Subject: 1-90 Allston, EEA, #15278

Re: I-90 Allston Interchange Project, Boston, MA
Draft Environmental Impact Report ("DEIR"), EEA No. 15278

Comment #3 : Draft EIR for I-90 (EEA #15278) : Traffic, Highway Design and AASHTO Standards

Plan of Throat Area for a Six-Lane Turnpike, no
breakdown lanes, no viaduct, all construction at
ground level. Includes CR Conservancy proposal
for a boardwalk over the river. Total width of green
space about 35 feet.

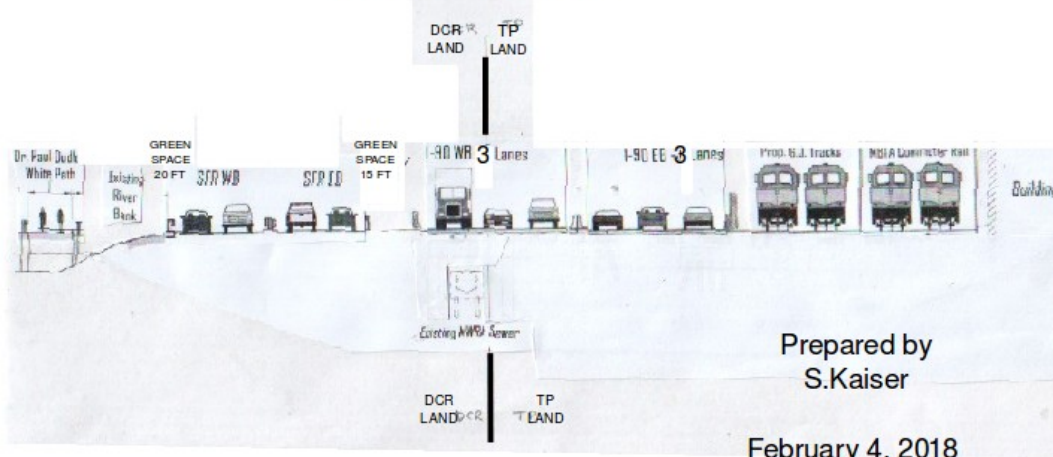
The "throat" area near Boston University presents a very tight corridor to include all of the functions intended : the Paul Dudley White path, riverfront vegetation, Soldiers Field Road, possible additional planting space, the Turnpike and potentially four tracks for commuter rail and freight. In addition, the DEIR proposed adding breakdown lanes -- the equivalent of two additional lanes to the eight-lane viaduct. This widening will result in expanding the viaduct into DCR parkland and squeezing the throat area even more tightly.

The practicality of a six-lane Turnpike means that 23 feet of extra space can be opened up in the throat cross-section. The primary beneficiary would be the ABC alternative. On the next page the recommended DEIR plan HV-3 is shown, with its heavy presence of elevated structure, and for comparison, the modified ABC option, with enough space now for a 15-foot planting strip between SFR and the Turnpike. This plan would also benefit from the Charles River Conservancy plan for a boardwalk or expanded parkland into the river within the throat section.

Draft EIR Plan HV-3 as Recommended with
viaduct extending 15 feet into DCR parkland.
25 feet of added breakdown lanes to meet "AASHTO
Standards")

MWRA Sewer Line requires careful excavation and
construction of pier footings and piles.

Figure 3.44. Specific reported speed-volume relationships per lane in one direction of travel under uninterrupted flow conditions on freeways and expressways.

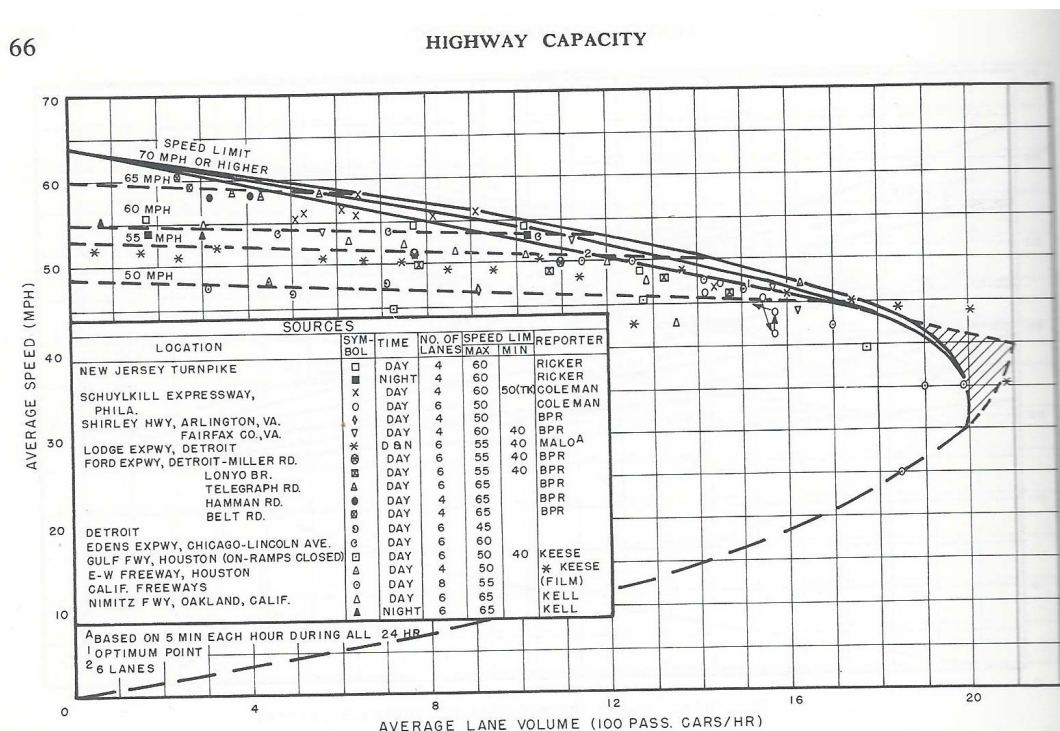
The numerical data also tells us that there is a complex relationship between speed and volume. The best description is contained in the 1965 edition of the *Highway Capacity Manual*, as shown in the graph below :

Off-peak travel speeds can be at their highest, with less dense traffic. As the volume increases, speeds drop to about 40 mph, when the volume in an expressway lane reaches a maximum capacity of 2100 vehicles an hour in each lane (Figure 3.44). The 2010 edition of the *Manual* shows more recent experience is 2,400 vph or more.

The situation changes as highways are pressured “beyond capacity” and begin to show congestion. The actual flow volumes go down and the speeds go down. This is exactly what we are seeing in the two videos and the state traffic count data. Figure 3.44 of the 1965 *Manual* shows this Level of Service condition as a dotted line because the counts vary considerably. In later editions (Third, Fourth and Fifth), the *Manual* presented the Level-of-Service F area as entirely blank, with no representation between speed and volume.

Measured counts demonstrate that the Turnpike cannot reach full capacity of 2,400 vph per lane or 9,600 vph for four lanes. The cause is the Newton bottleneck. The videos show traffic at its most congested state, moving at a rate of less than 3,000 vehicles per hour (vph). The lowest flow over a full hour is 3,880 vph. The average flow is 4,670 vph. Maximum flow is 5,616 vph. Even the maximum flow of 5,616 is only 60% of the 9,600 capacity and the average flow of 4,670 vph is less than half. The bottleneck has the effect of partially disabling the Turnpike.
